TECHNICAL MEMORANDUM: REVIEW OF THE DRAFT DISCHARGE PERMIT AND APPLICATION, COPPER FLAT COPPER MINE

Sierra County NM

May 1, 2018

Prepared by: Tom Myers, PhD, Hydrologic Consultant, Reno NV

Figure 2: Figure 6.6 from Jones et al (2014).

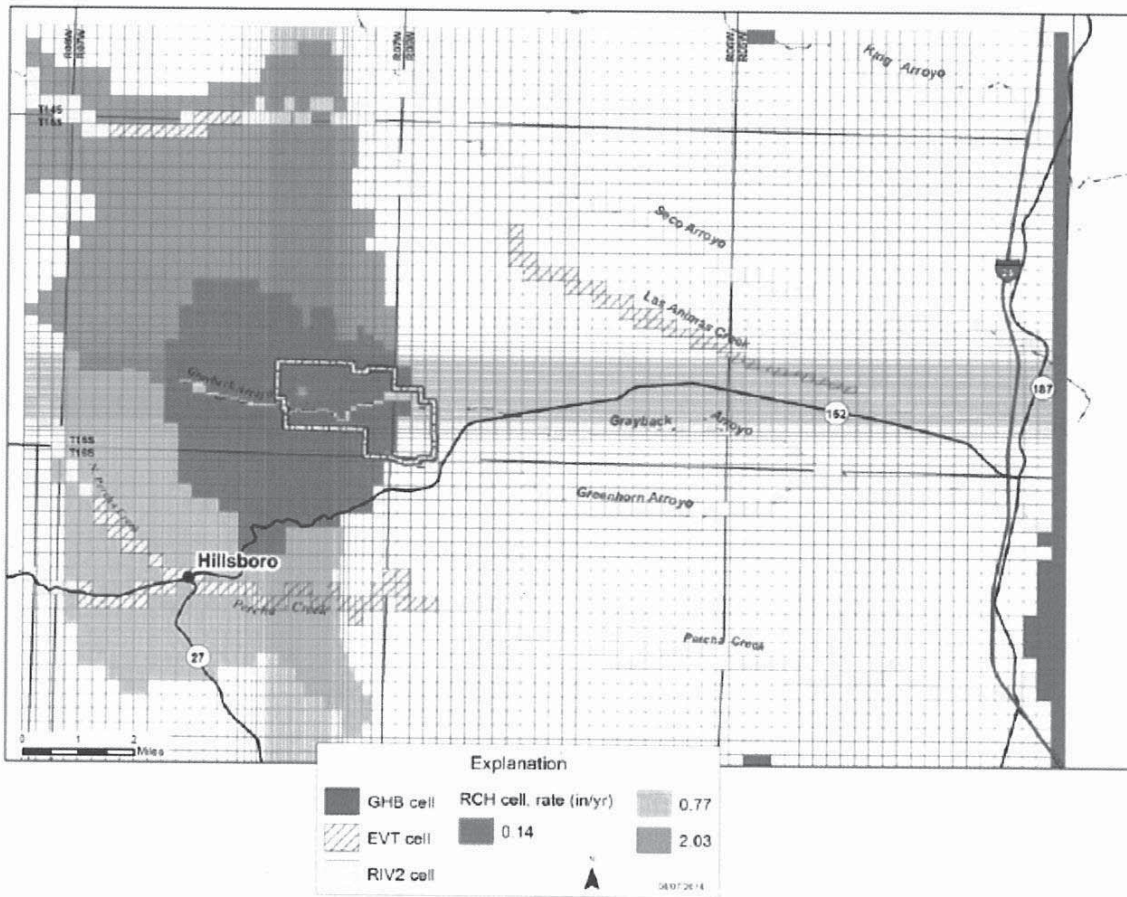
The groundwater model steady state calibration (Jones et al 2014, section 6.3) balances recharge with discharge to surrounding streams. The pinkish area in Figure 2 is the andesite and has recharge equal to 0.14 in/y; the area east of that is the Natomas basin which has no recharge. The rate corroborates the rate estimated above for offsetting the dewatering and evaporation rates. Because groundwater discharges other than to the pit lake, such as to springs, streams, and the Rio Grande downgradient from the Mine area, the calibrated recharge rate is clearly too low.

Simulated recharge is of meteoric water, rainfall and snowmelt, which occurs intermittently during specific events. Although the MODFLOW modeling is an empirical estimate and not a simulation of the physical process, it still represents a process that occurs only when water is available. Only 0.14 in/y is available because during the short-term events the water availability overwhelms the capacity of the ground surface to allow it to percolate so that that much of it runs off. A waste rock stockpile, prior to reclamation, would allow much of the meteoric water to enter and pass to the ground surface (the andesite) uniformly so that it would not runoff and would have full opportunity to enter the ground surface. The effective rate that water would reach the ground surface would exceed 0.14 in/y by many times and would do so much more uniformly with opportunities for seepage to enter the andesite lasting for much of the year.

It is very likely that waste rock would cause more meteoric water to enter the ground. Andesite is not similar to a liner, because the average K is too high, it is fractured, and the waste rock would cause the water to reach the soil much more uniformly than it would without the waste rock. The DP Application (p 65) is not accurate where it states the permeability of the andesite is less than 10^{-6} cm/s; all of the estimates in Jones et al (2014) Table 5.2 exceed 10^{-5} cm/s. Therefore, Jones et al's modeling yielded conductivity values that contradict the andesite impermeability assumption in the DP Application.

Figure 3: Figure 3.16 from Jones and Finch (2017) showing the water table near pit at the end of mining and 100 years after the end of mining.

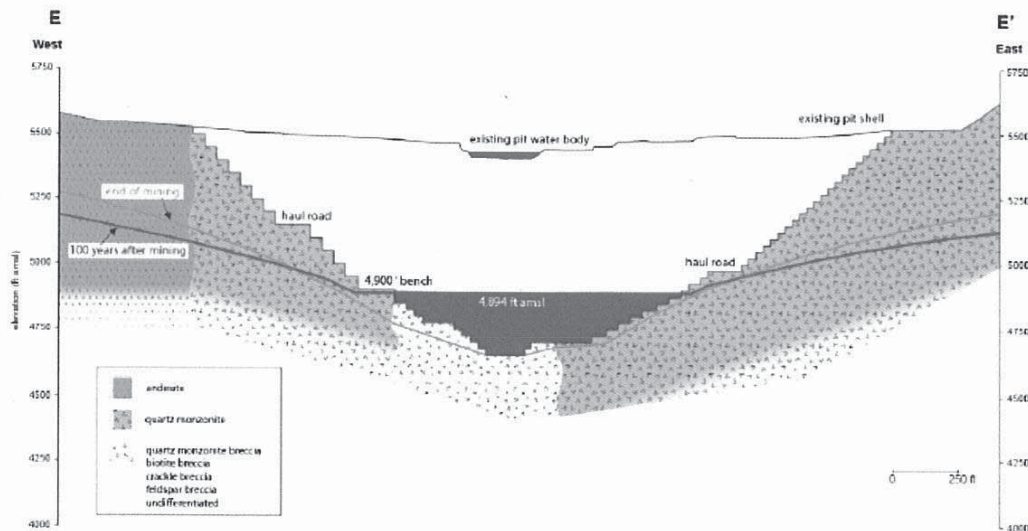
The first reason the simulated water table is inaccurate is that the calibrated andesite K is two orders of magnitude less than the measured values. Therefore, the water table drawdown forms a steep cone near the pit, as shown in NMCC's modeled results in Figure 3. If the K was higher, as measured, there

would be much additional aquifer volume between the pit and the drawn-down water table. Additionally, the model parameterization ignores the results of the pressure injection tests, in that the testing found that K at depth was greater than in shallow areas, but the parameterization assumed the highest layer had the highest K. There is no basis for the Jones et al (2014) assumption of decreasing K at depth because they conducted no analyses of permeability at levels lower than 250 feet bgs.

The third reason the simulated water table is inaccurate is the drawdown cone generated by dewatering in a formation with higher K would be much more spread out, and flatter, than the one shown in Figure 3. Drawdown caused by dewatering in a sloped groundwater table, west to east as occurs pre-mining at the Mine, forms a groundwater divide²² east of the pit. This “capture zone” defines an area from which water will be drawn to the pit, or pit lake. The elevation of the groundwater divide depends on the K of the formation in which it is calculated, the recharge entering the formation near the pit, and the steepness of the original water surface through the pit. The groundwater divide in a more conductive pit formation would occur further downgradient from the pit and therefore would be lower because the pre-mining water table would be lower. The groundwater divide would also be lower if the pre-mining groundwater table was steeper. Higher recharge would increase the water flowing to the pit and needing to be dewatered, so for a given K it would raise the groundwater divide because a higher gradient would be required to cause the water to flow toward the pit.

The fourth reason the simulated water table is inaccurate is that fracture zones in the pit formations would cause the groundwater table near the pit to be irregular, and the divide could form further from the pit and at a lower elevation in a high K fracture zone. The groundwater divide in these zones would possibly be lower than the final pit lake elevation estimated by NMCC based on a homogeneous pit formation, so these zones provide possible pathways for water to escape the forming pit lake to reach downgradient groundwater.

NMCC has clearly not analyzed this potential nor presented evidence to support its assumption of no fracture zones. Analysis could be accomplished within the model by increasing the K by two orders of magnitude to reflect the measured values, and by creating potential zones with even higher K. However, due to the lack of mapping of these zones, they could be tested only theoretically.
